COMMONWEALTH OF KENTUCKY
BEFORE THE KENTUCKY STATE BOARD ON ELECTRIC
GENERATION AND TRANSMISSION SITING

<i>Electronic</i> Application of Golden Solar, LLC)	
for Certificate of Construction for an)	
Approximately 100 Megawatt Merchant)	Case No.
Electric Solar Generating Facility in Golden)	2020-00243
County, Kentucky)

Response to Siting Board Staff's Second Request for Information

Figure No.
ESB-02-10

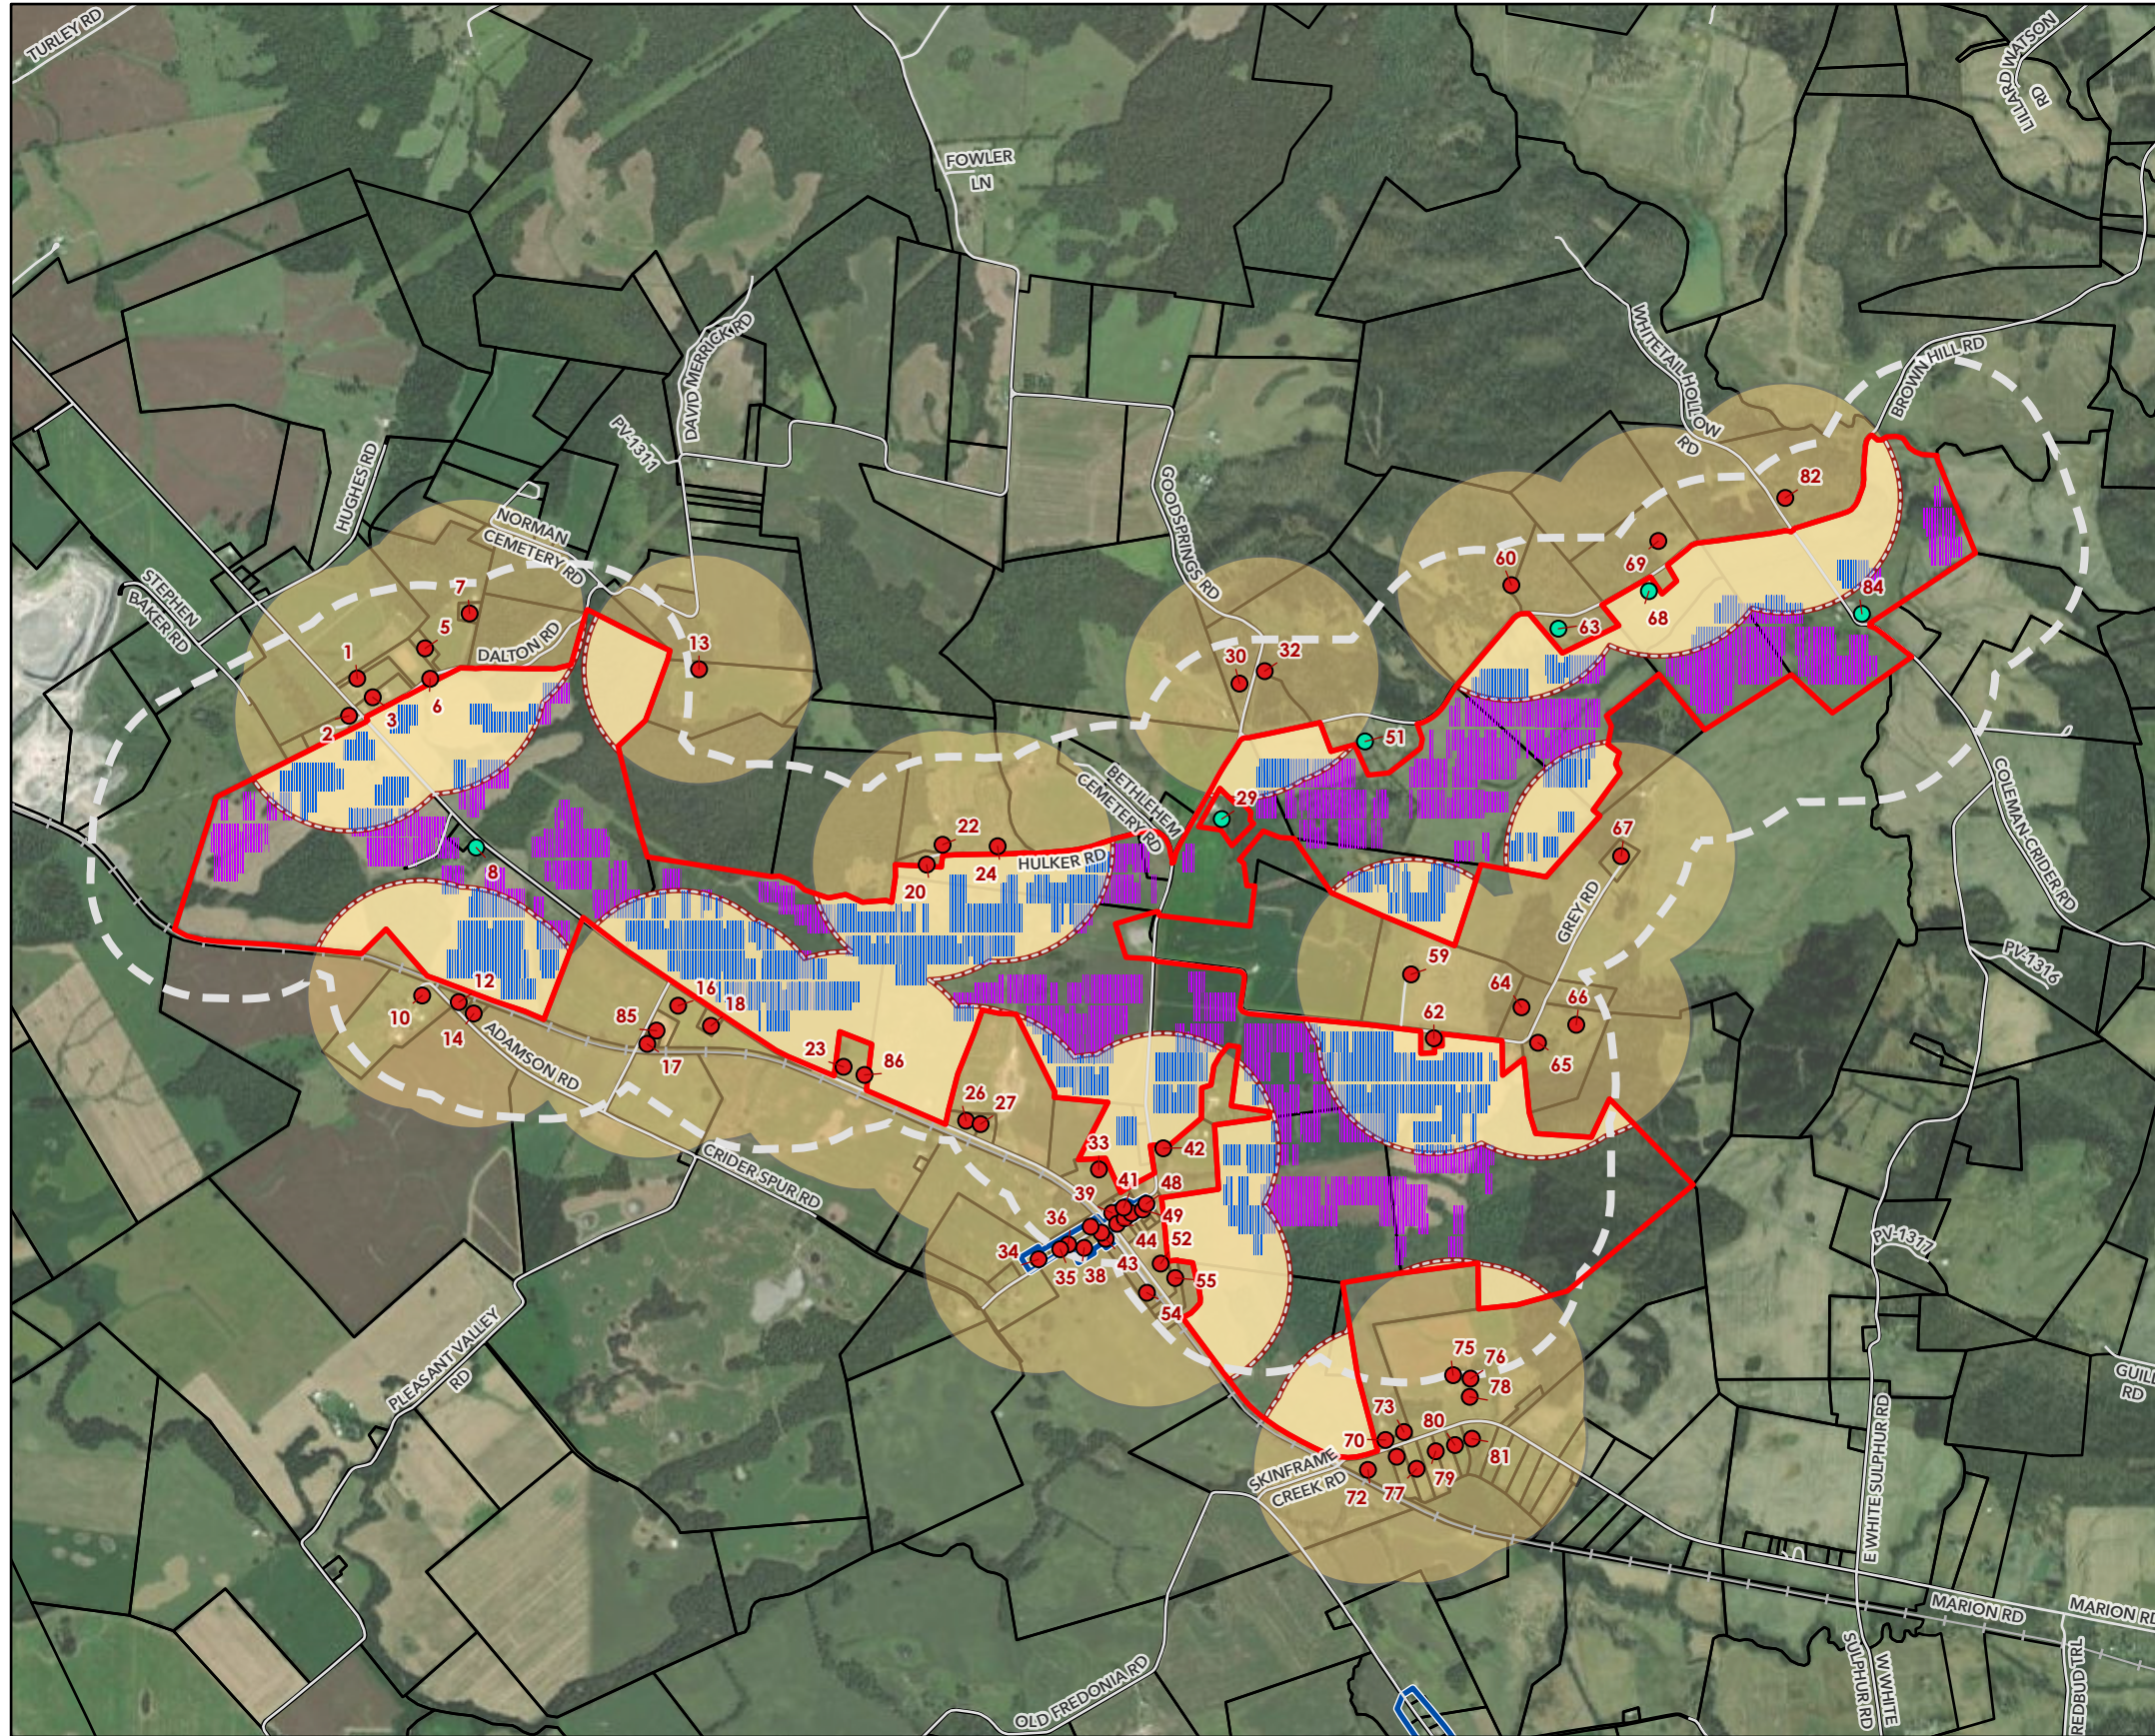
11. Refer to the Response to Staff's First Request, Item 24. Use the following assumption and provide a sound contour line at 55 dBA: 3 pile drivers operating simultaneously in close proximity adding 5 dBA to maximum pile driver sound levels and that the sound would be continuous rather than intermittent.
-

For the reasons described in the Response to 2 ESB 10, this hypothetical is based on an assumption that is overly focused on the temporary impact of construction activities and the variability of sound and conditions, with no proven dampening approach. Notwithstanding the above, please see the attachment labeled ESB-02-10 Layout.

DATE: 11/17/2022
 SHEET: C.200

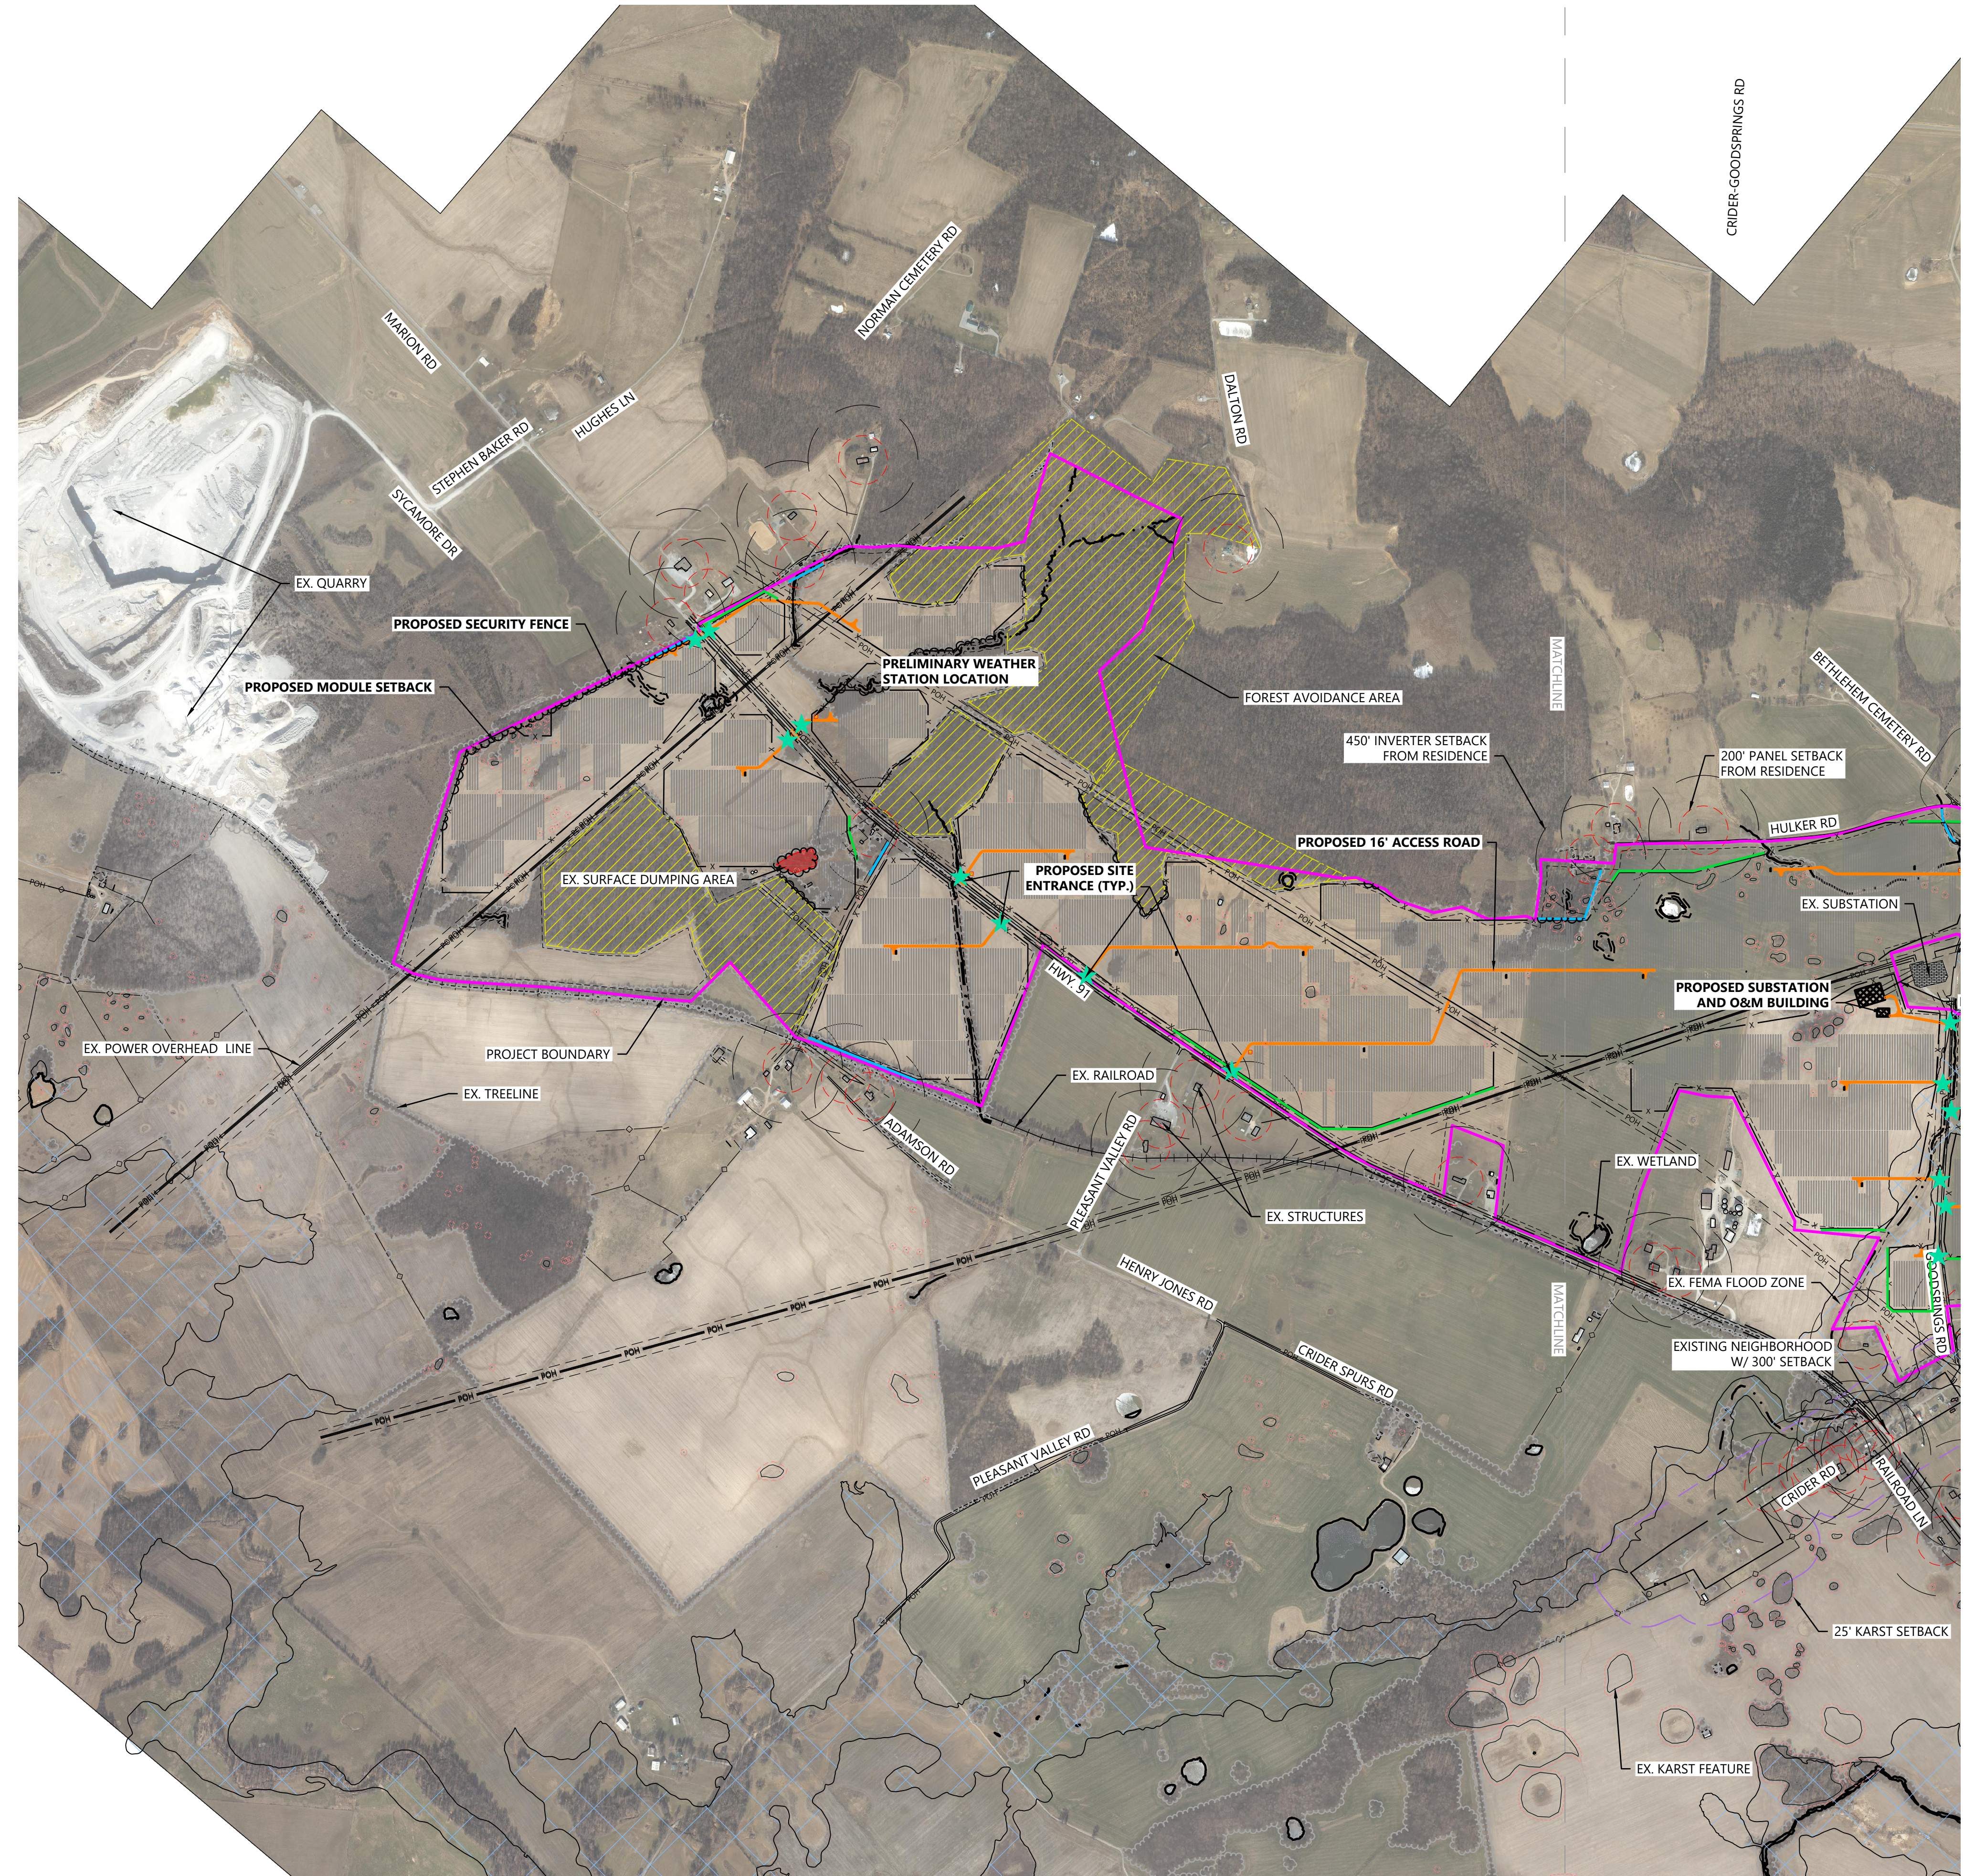
14. Refer to the Application, Exhibit J, Preliminary Site Plan Set, page 2. Explain what the “surfacing dumping area” referenced in the site layout will be used for.

Amended Exhibit J- Golden Preliminary Plan Set has been updated to more accurately reflect the surface dumping areas and is attached hereto. These existing dumping areas were identified during the Phase I ESA and are described in detail in the Phase I ESA report. The dumping area on Sheet C-200 is described on Page 13 and appears on Figure 2 of the June 2020 Phase I ESA (Application Exhibit H Attachment H). This area was considered a Recognized Environmental Condition (REC). The dumping area on Sheet C-201 is described on Page 11 and appears on Figure 2 of the Aug 2021 Phase I ESA (Additional Areas) (Application Exhibit H Attachment H). This area was not considered a REC. These dumping areas were included in the site plans to show the avoidance areas and are not proposed to be used for the Golden Solar project.
